# CLARIFICATIONS ON NC RFG & NC DCC

Ljubljana, 9 December 2016

## EU Regulation 2016/631 (NC RfG)

## 2. Response time of LFSM-O

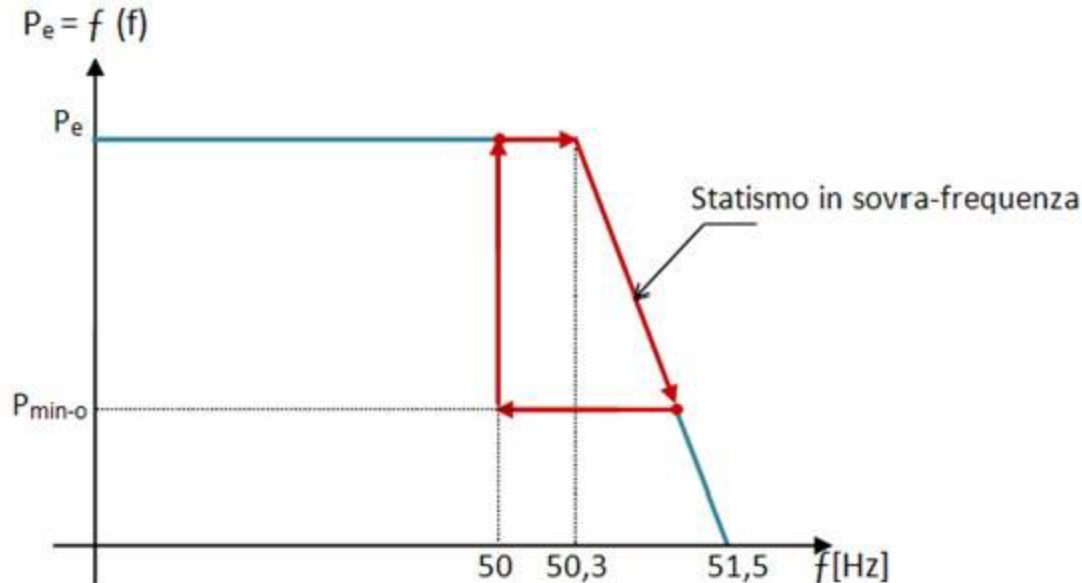
- How to deal with this technical issue?

- Article 13(2) does not state a required response time, but only an initial delay what we understand as a dead time.
- ENTSO-E's publication *"Frequency Stability Evaluation Criteria for Synchronous Zone of Central Europe"* states that a response time of 1s is an appropriate requirement.

- Only PV is capable of such a rapid response.\*
- TS 50549: A response time of 2s with the allowance of staged disconnections, in case a generating unit is not capable to reduce output power with the required dynamic response.

- NC RfG EU 2016/631 explicitly forbids this solution for units above Type A but most generating plants will not be capable to response to LFSM-O within 1 or 2s.

- **To avoid excluding most generating technologies (Wind, Internal combustion, Gas Turbines) from being compliant with planned EN 50549 we need to increase the response time up to 15 to 30s, but propose to define a dead time (in the range of 1 to 2s).**

- **This however would be in direct conflict with the ENTSO-E publication cited above.**
